## ADDENDUM NO. 1

PROJECT: Saline Area Schools – 2022 Bond Program – MS Rec Complex  
 DESCRIPTION: Addendum No.1  
 BID PACKAGE RELEASE NUMBER: BP #3

1. ADDENDUM No. 1, November 20<sup>th</sup>, 2024 as issued by Kingscott (Attached)
2. Bid Package T4 Draft Drawings, October 22<sup>nd</sup>, 2024 - Saline Middle School Rex Complex as issued by Barton Malow (For Reference Only)

# C3.9

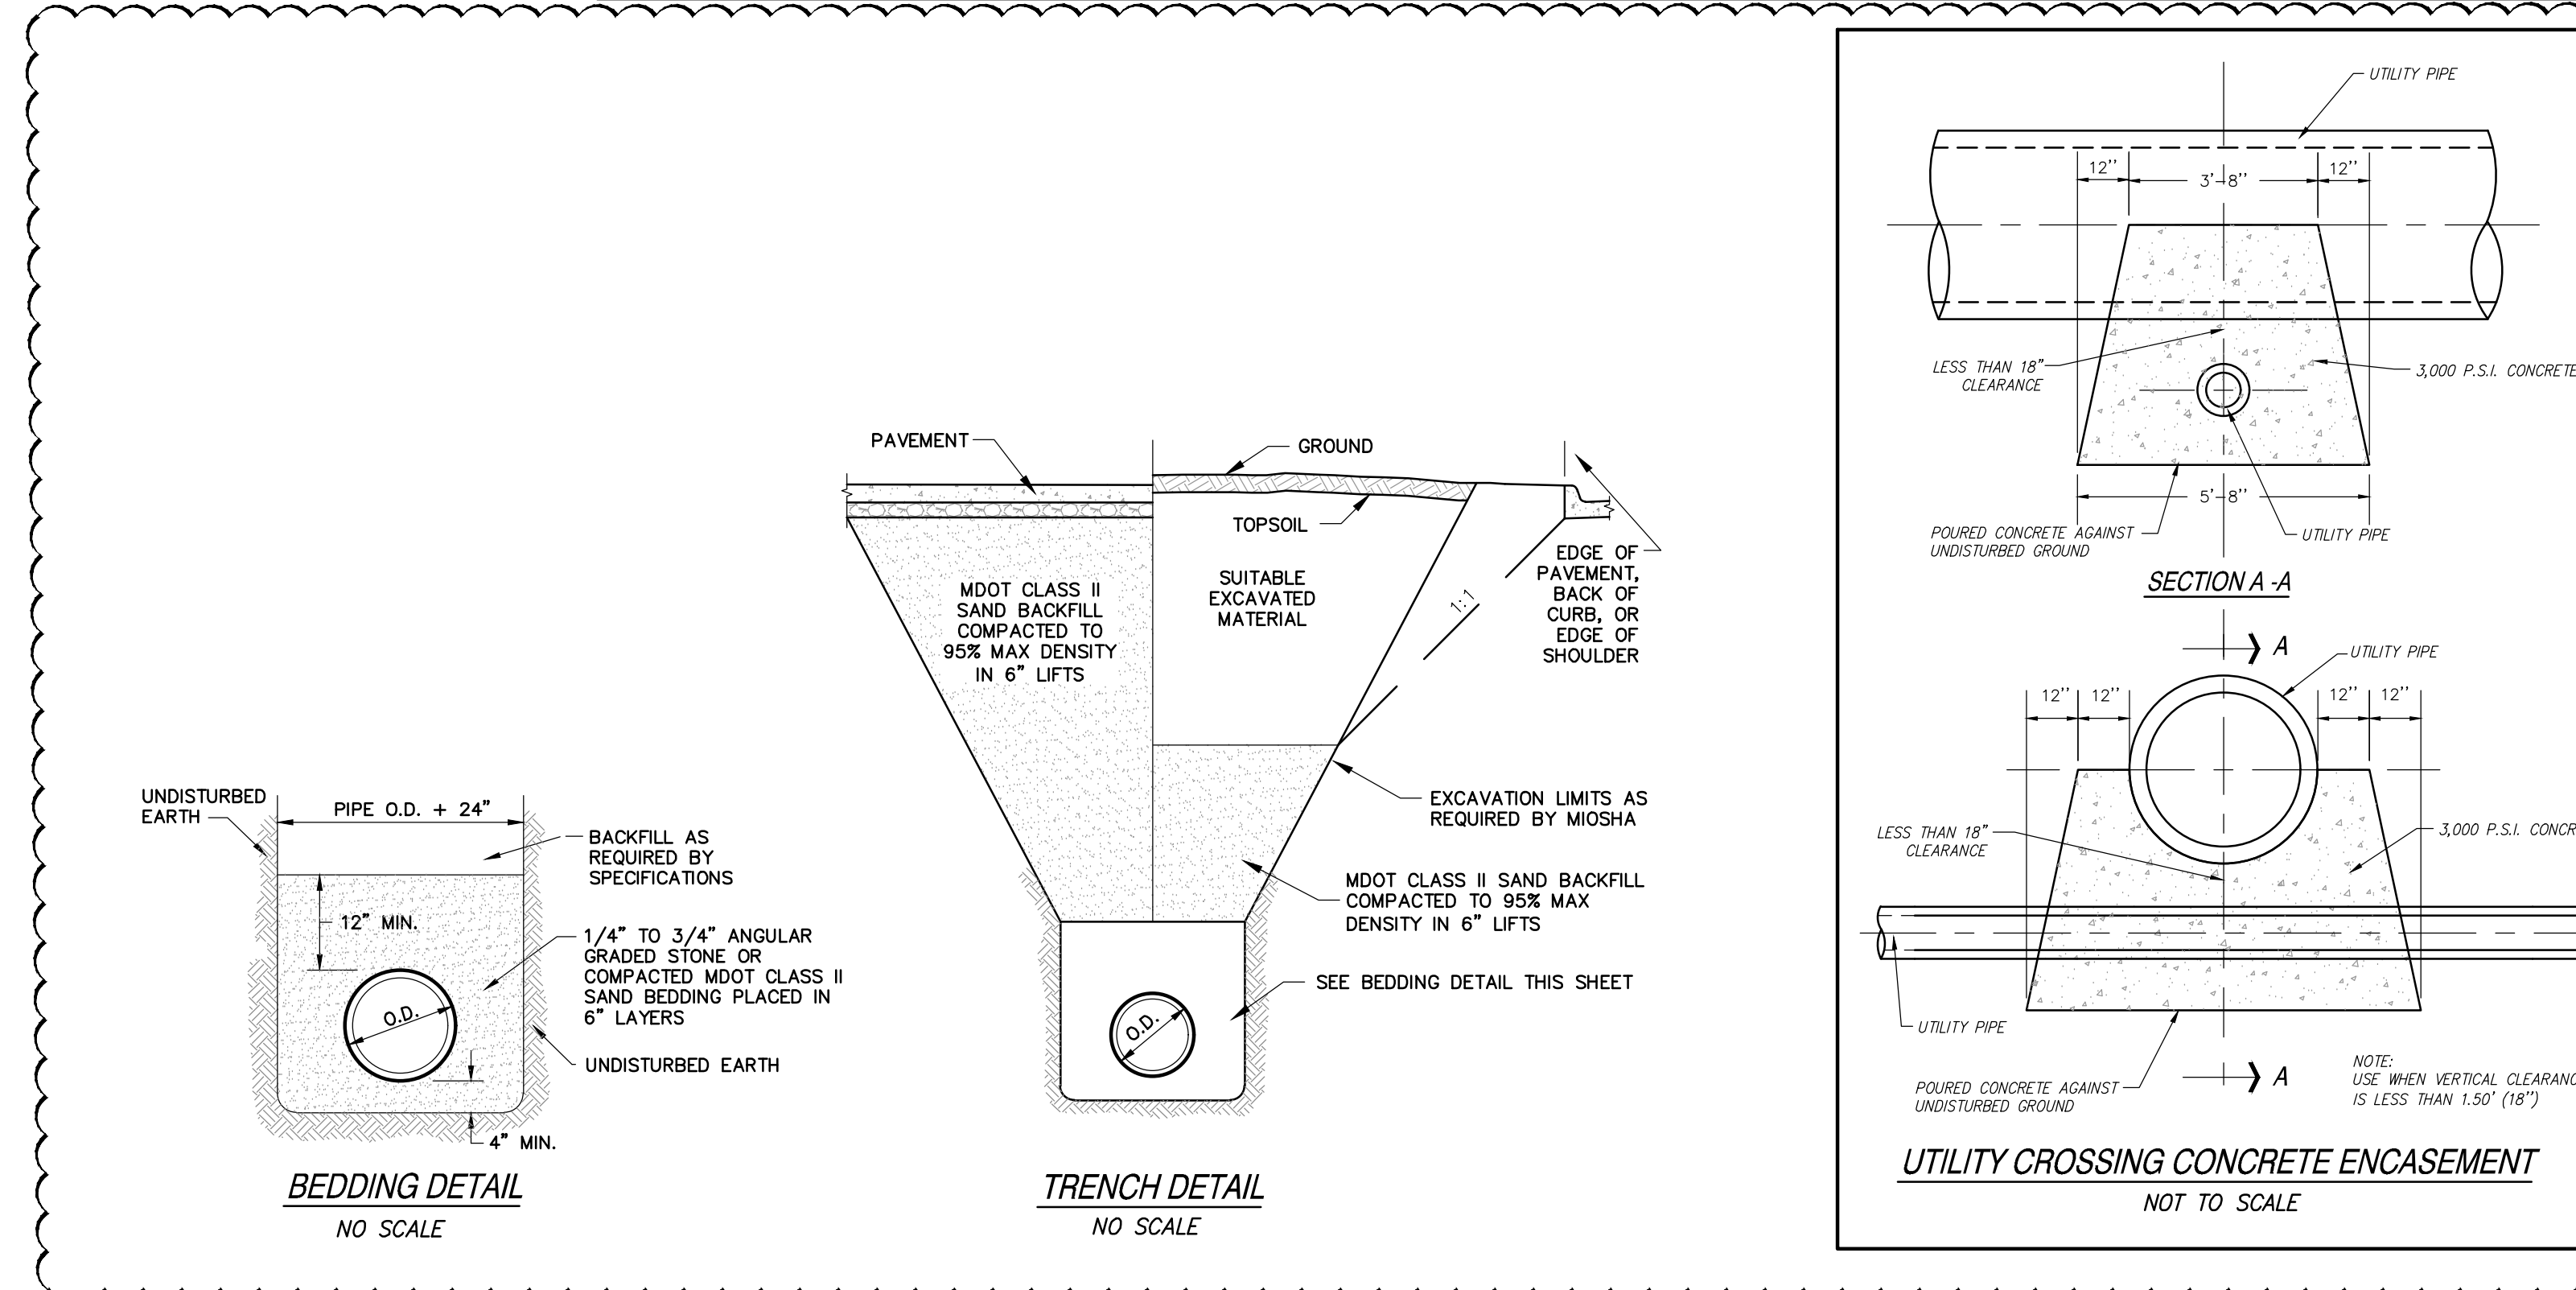
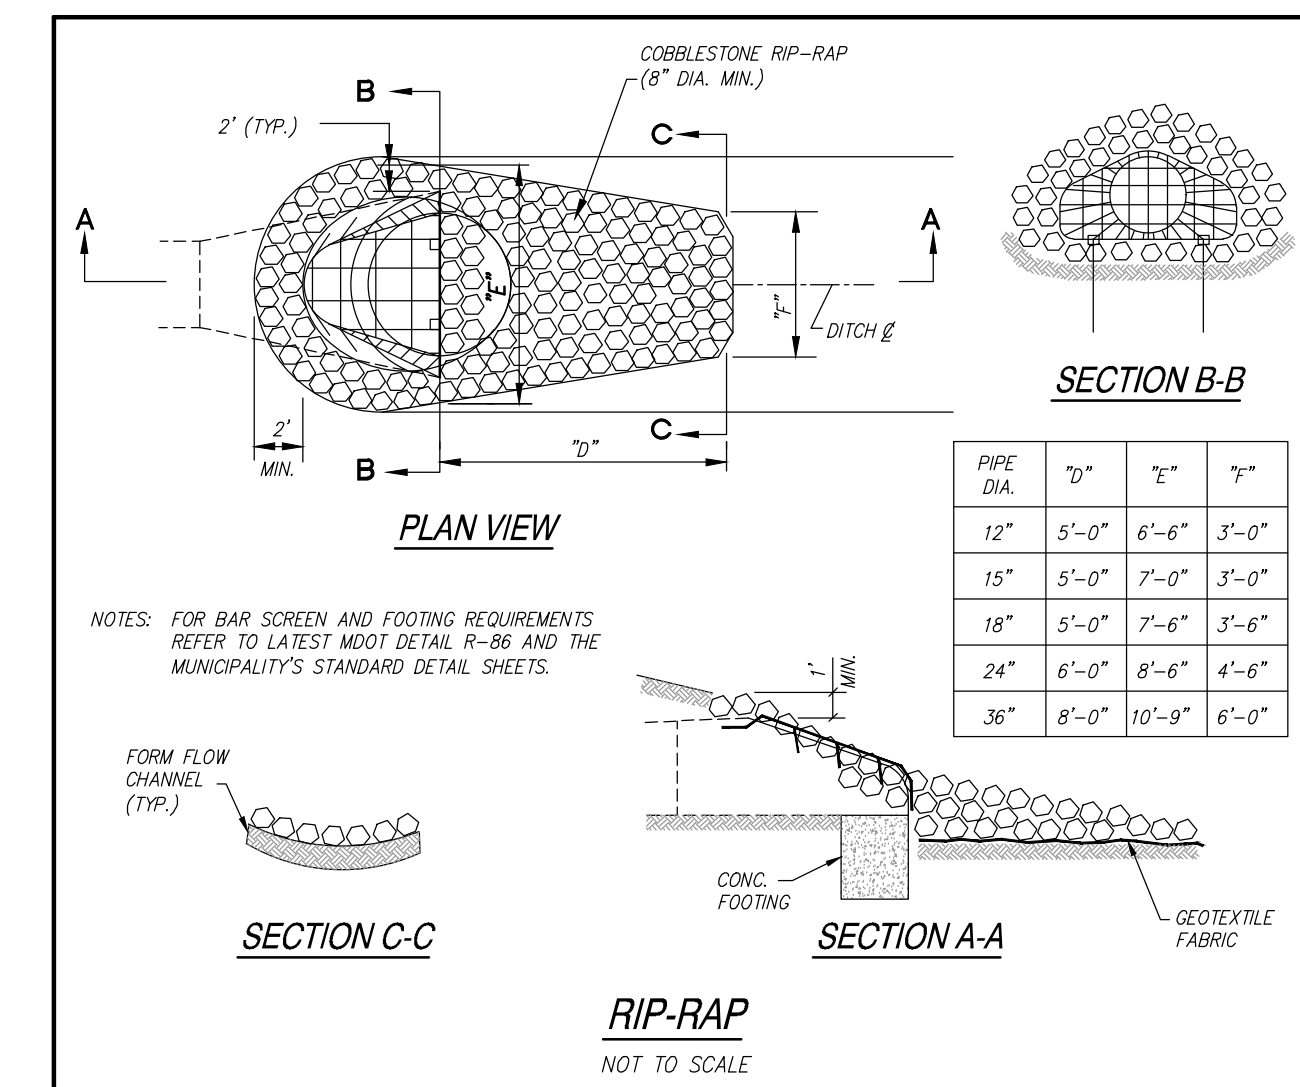
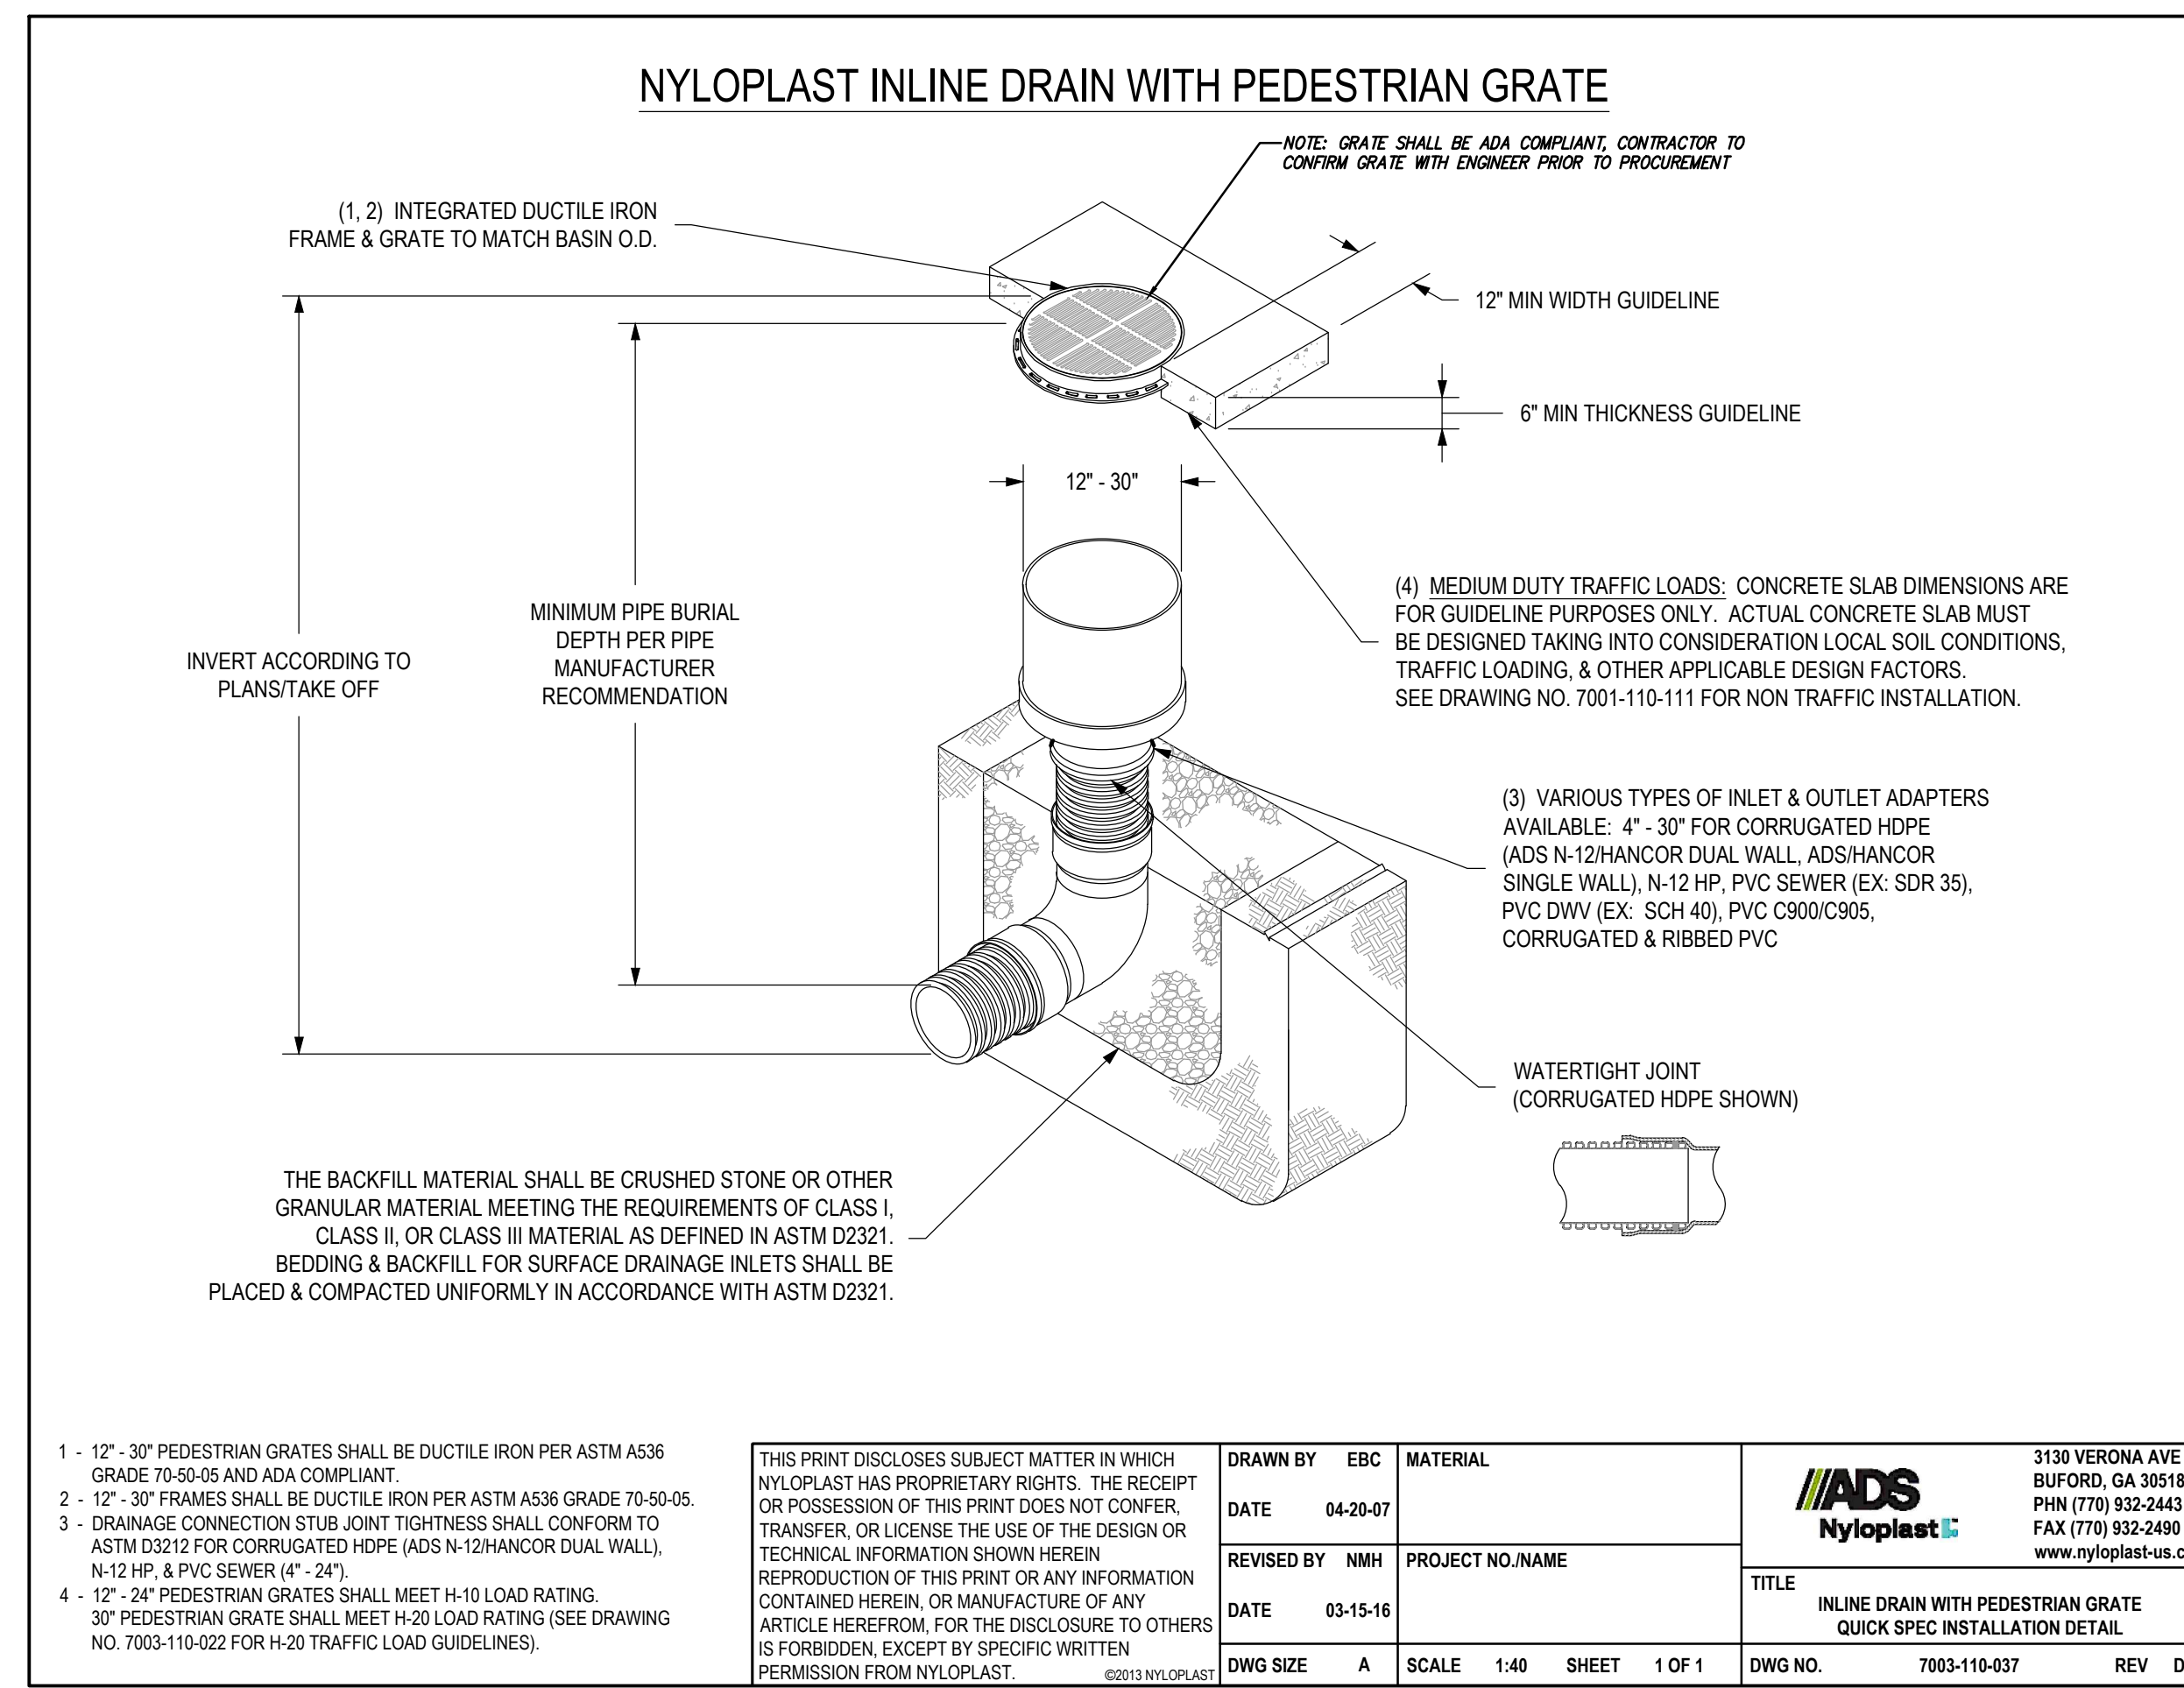
- Item No. 48: Added utility crossing number(s) and crossing table(s) on sheet C3.7.
- Item No. 49: Added "Utility Crossing Concrete Encasement", trench, and bedding details to sheet C3.9.
